IN THE DRAWINGS:

Fig. 6

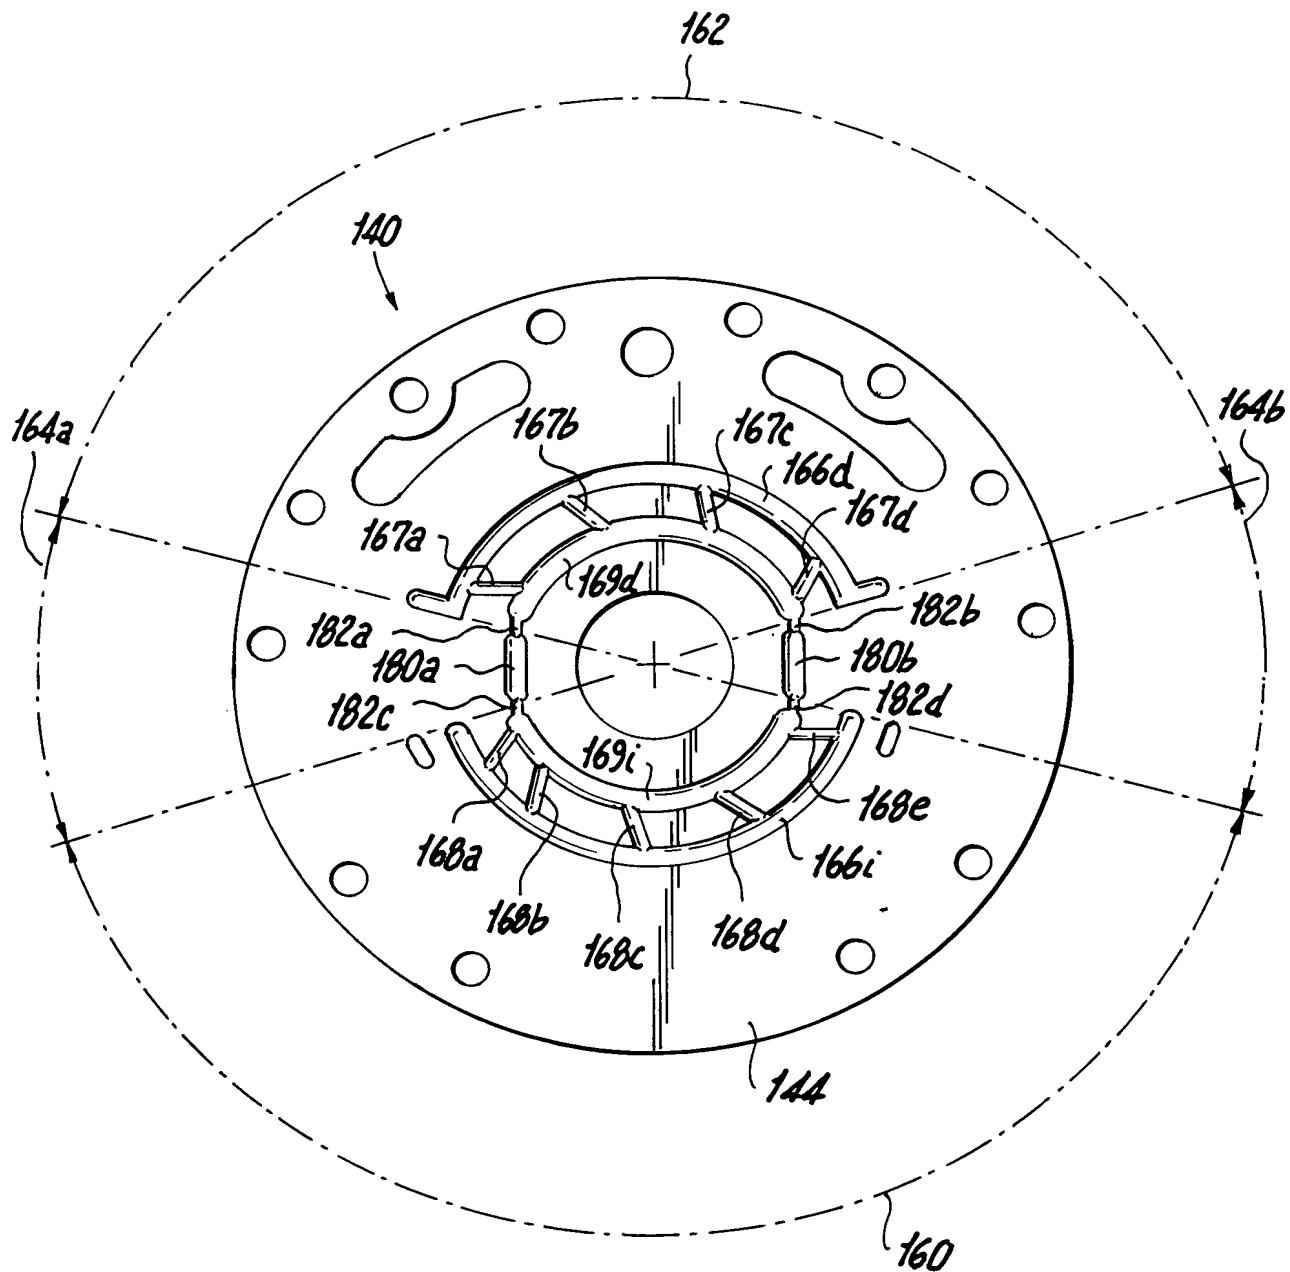
Please replace Figure 6 of the drawings as originally filed with the attached replacement sheet to properly identify channel 166d.
